VIRGINIA ELECTRIC AND POWER COMPANY
RICHMOND, VIRGINIA 23261

VIRGINIA ELECTRIC AND POWER COMPANY
SURRY POWER STATION UNITS 1 & 2
CORE UPDATE LICENSING REPORT REVISION
STEAM GENERATOR TUBE RUPTURE REANALYSIS

**SURRY CORE UPRATE LICENSING REPORT
TABULATION OF CHANGES**

**SURRY CORE UPRATE LICENSING REPORT
REVISED PAGES**

Figure 3.5.9-7

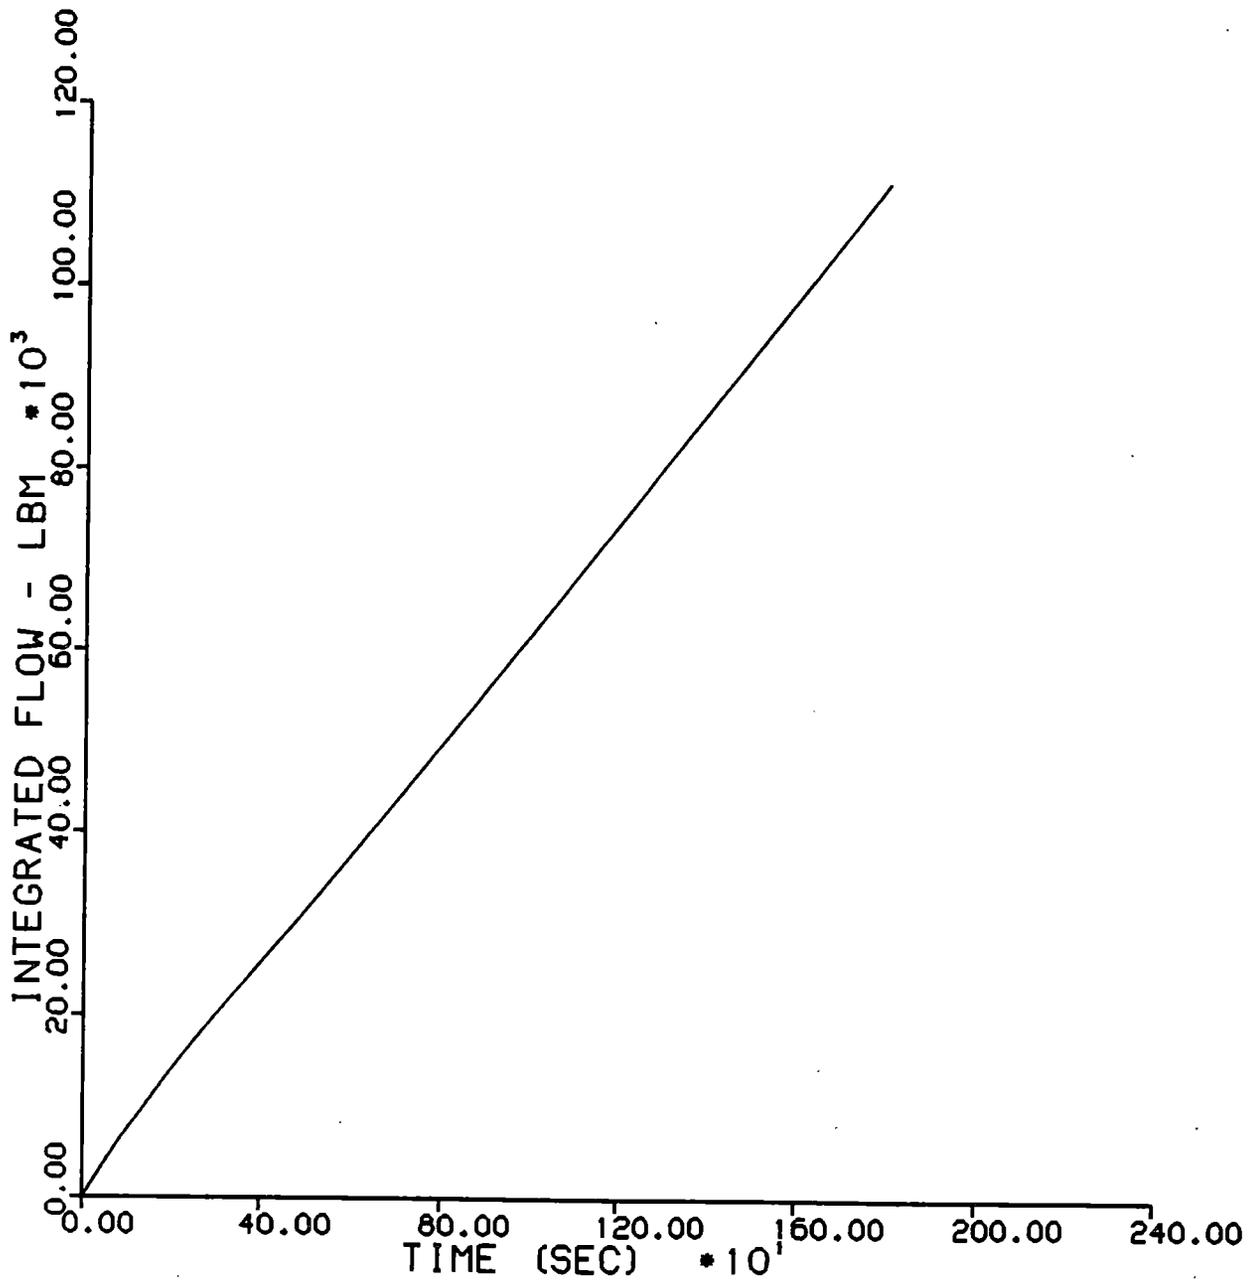
Figure 3.5.9-7 - Integrated Break Flow: At one-half hour after initiation of the event, approximately 111,500 lbm of fluid has been transferred from the RCS to the secondary side of the ruptured steam generator.
